UNITED STATES PATENT AND TRADEMARK OFFICE

APPLICATION NO.	FILING DATE	FIRST NAMED INVENTOR	ATTORNEY DOCKET NO.	CONFIRMATION NO.
10/511,071	10/12/2004	Steven Victor Jones	BR8812	7044
7590 04/28/2006 The Black & Decker Corporation Mail Stop TW199 701 East Joppa Road Towson, MD 21286			EXAMINER MITCHELL, KATHERINE W	
			ART UNIT 3677	PAPER NUMBER

DETAILED ACTION

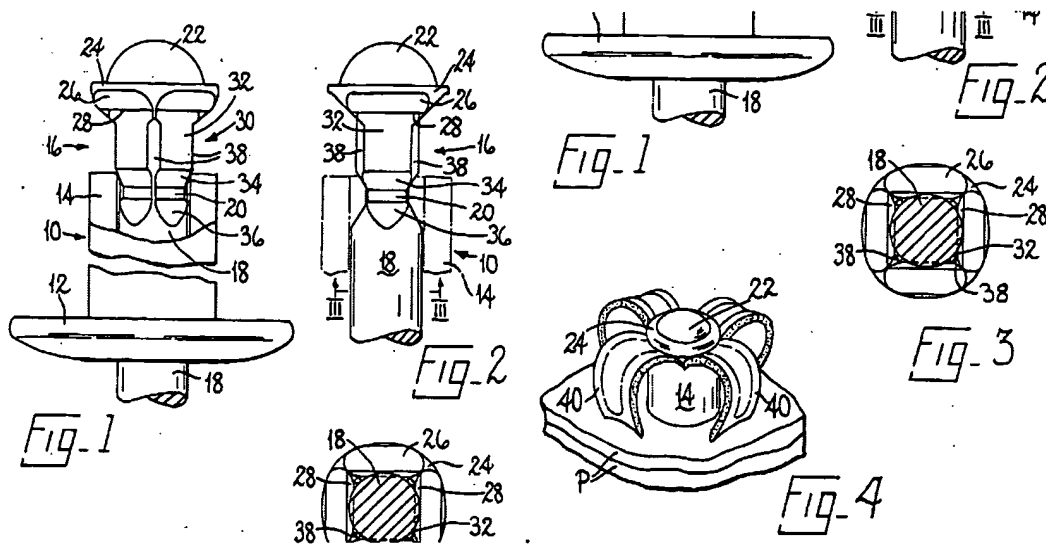
Re claims 1-2: Potzas in Figs 1-4 (above) teaches Potzas teaches a peel type blind rivet (abstract) settable in soft material, having an elongate body 10 with a shank and preformed head 12 at one end, and a plurality of slots 12 terminating at the end remote from the head. There is a mandrel (16, column 2 lines 49-50) having a stem (18) which extends through coaxial with said body and having an enlarged head (22) with a maximum external diameter greater than the internal body diameter (Figs above). The mandrel head forms a shoulder between the mandrel stem and an outer surface of the head, -- the deforming means (head) presents a substantially flat surface perpendicular to an axis of said mandrel, in that the underside of head 22 terminates in plane forming flat shoulders 28 normal to axis of stem, which as shown in Figs 1- 4 and discussed in column 2 lines 62-68 is described as "flat shoulders 28 normal to the axis of the mandrel".
